Public Works Project No. 89006007-23-034-C1

I-70 WB Centerville Welcome Center  
INDOT

**ADDENDUM NO. 1**

October 1, 2024

Drawing Number: WC/M3-1

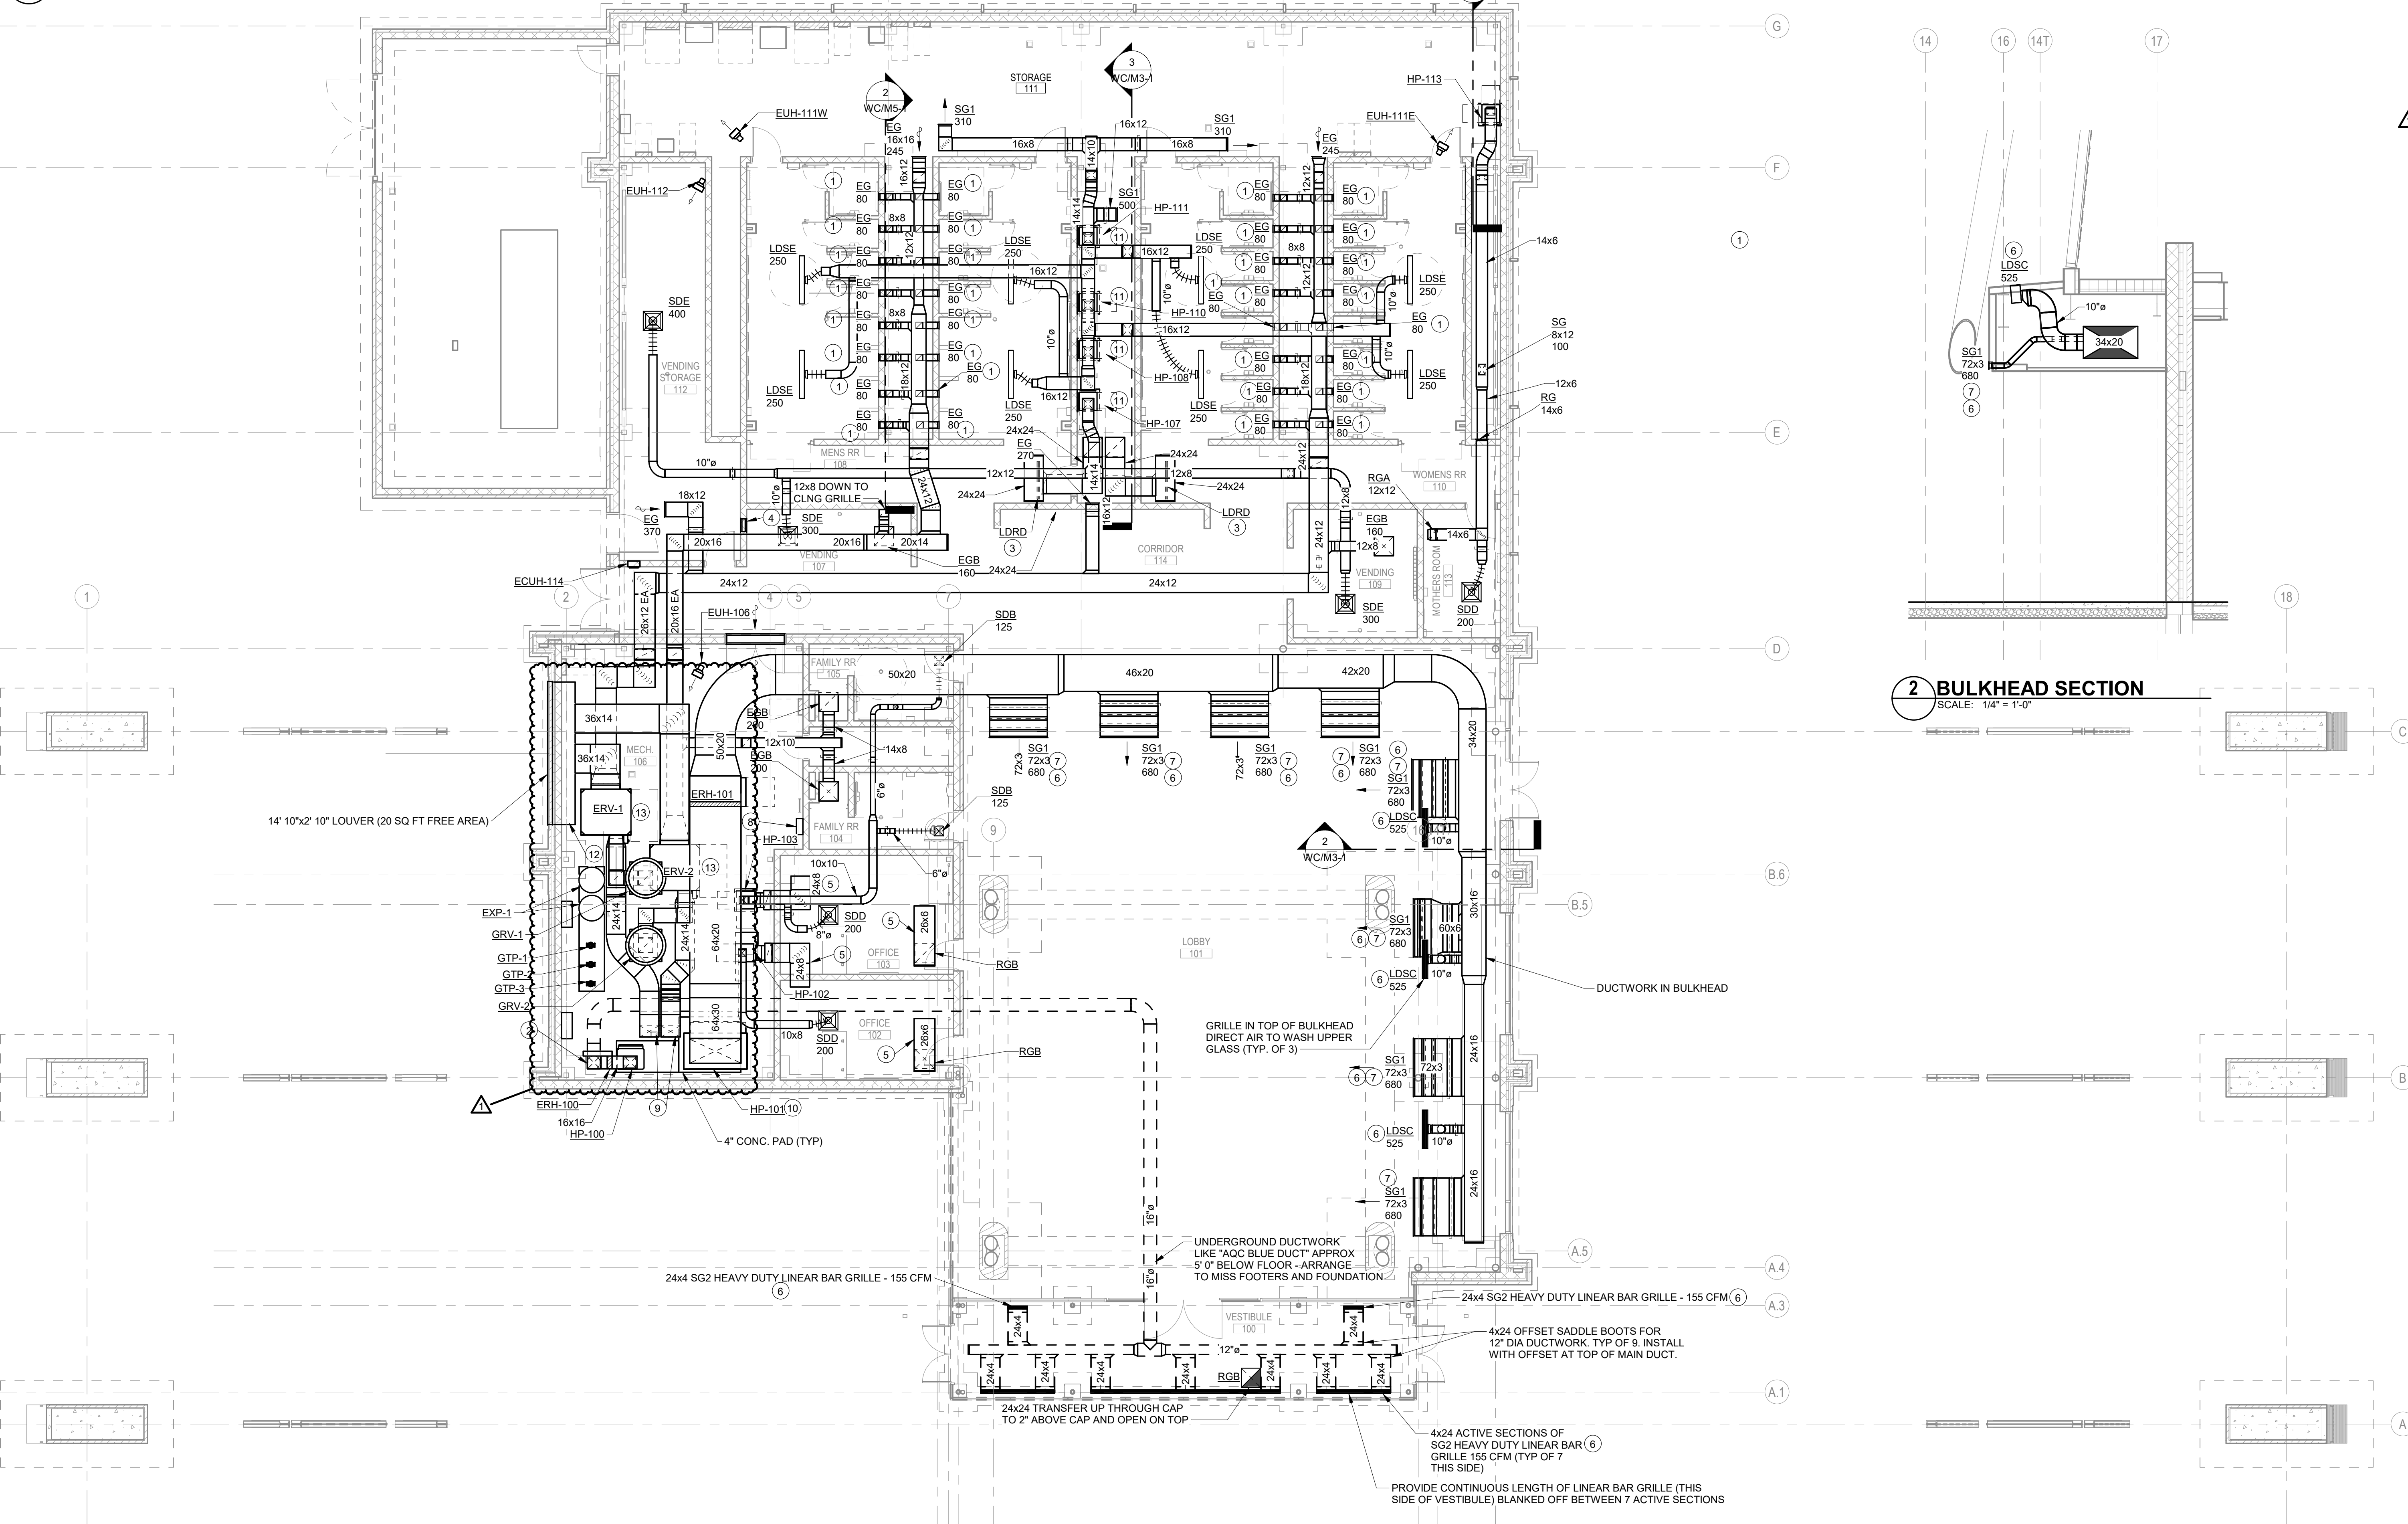
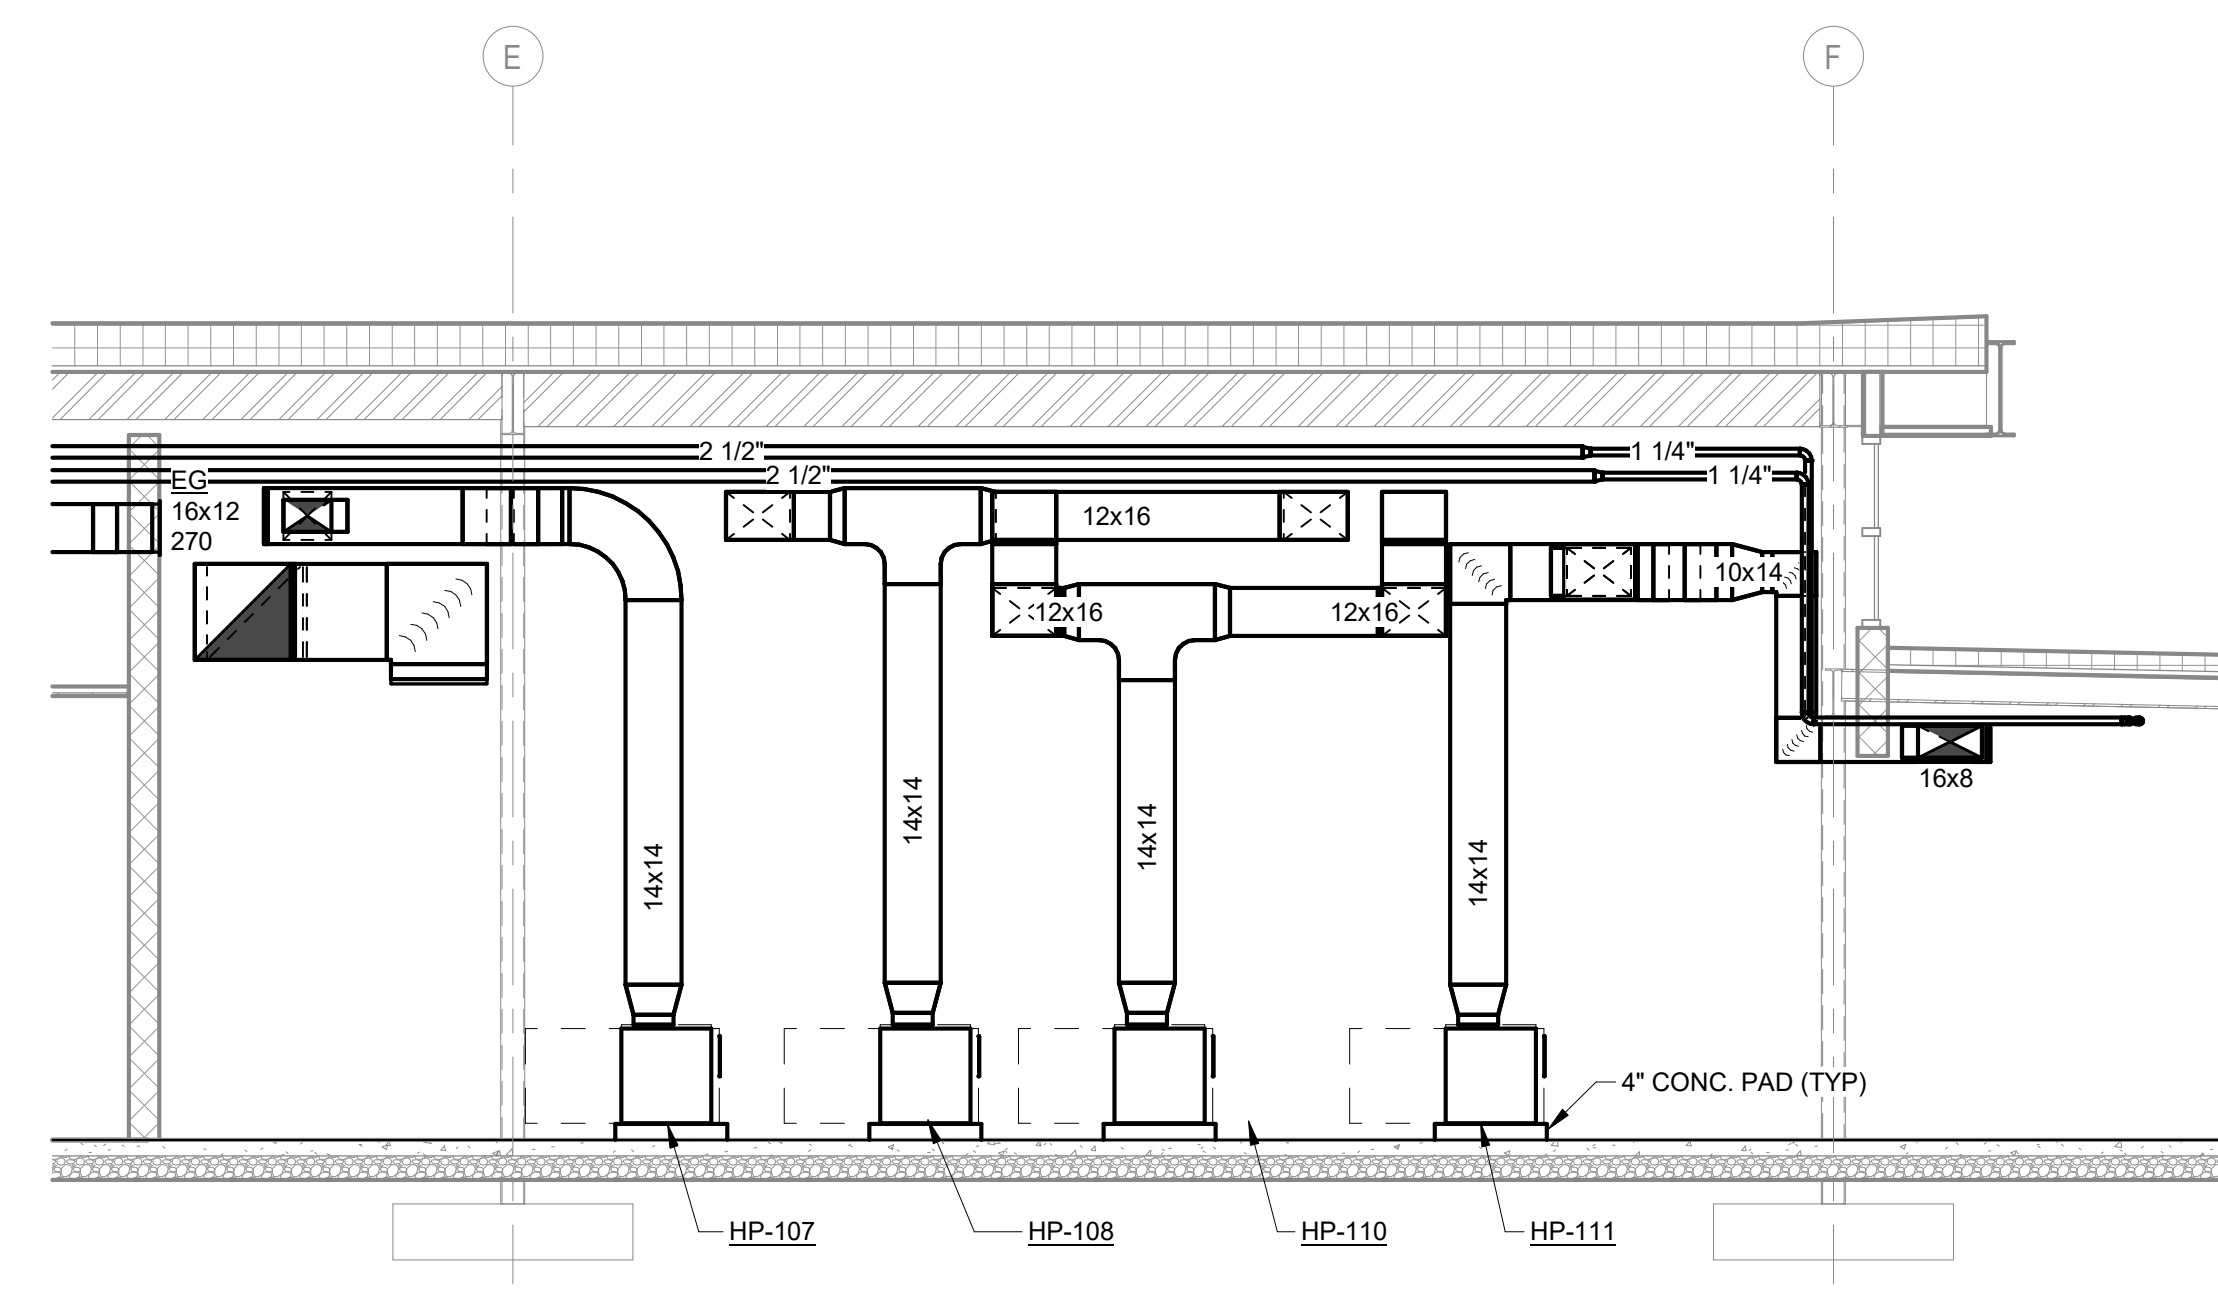
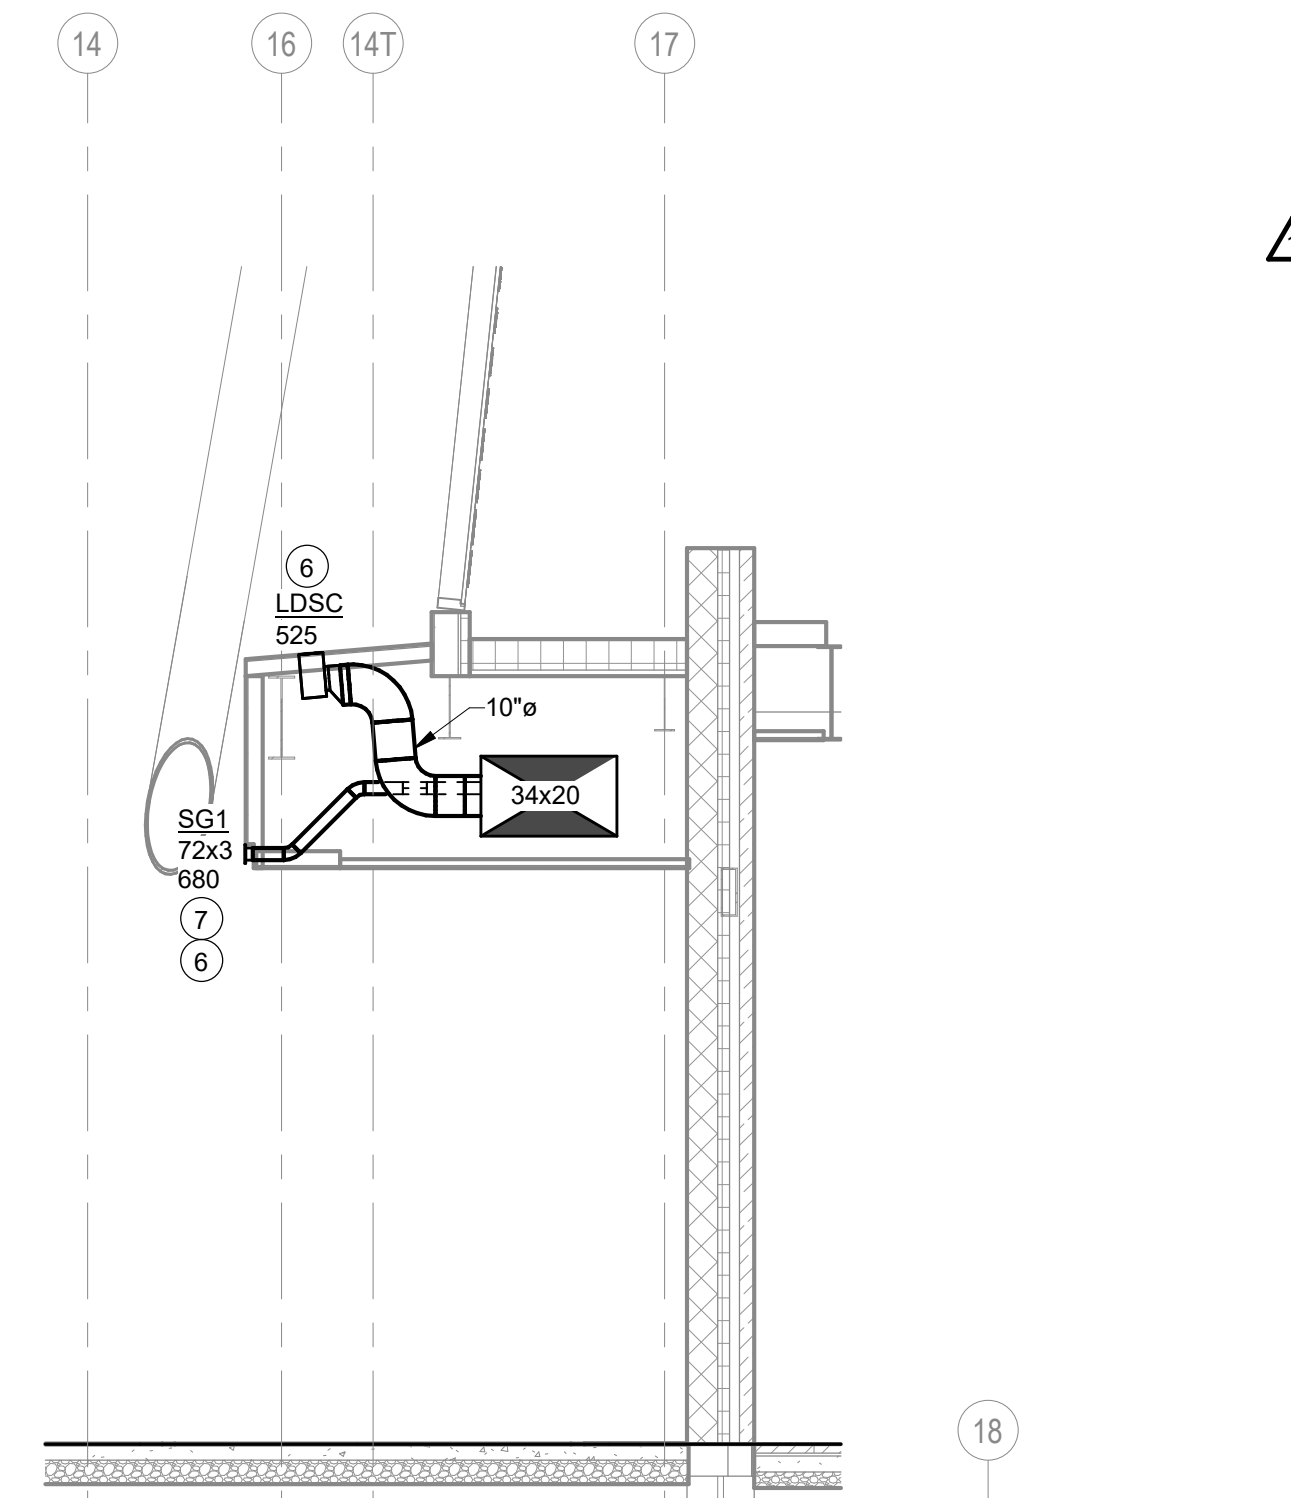
- Item No. 7-A1:**                    **Drawing Set #1, Sheet M3-1 WELCOME CENTER HVAC FLOOR PLAN**  
Replace:                                Replace Sheet M3-1 with attached Sheet M3-1  
Revise ductwork in mechanical room for better access to energy recovery ventilators. Change size and duct layout of HP-101.
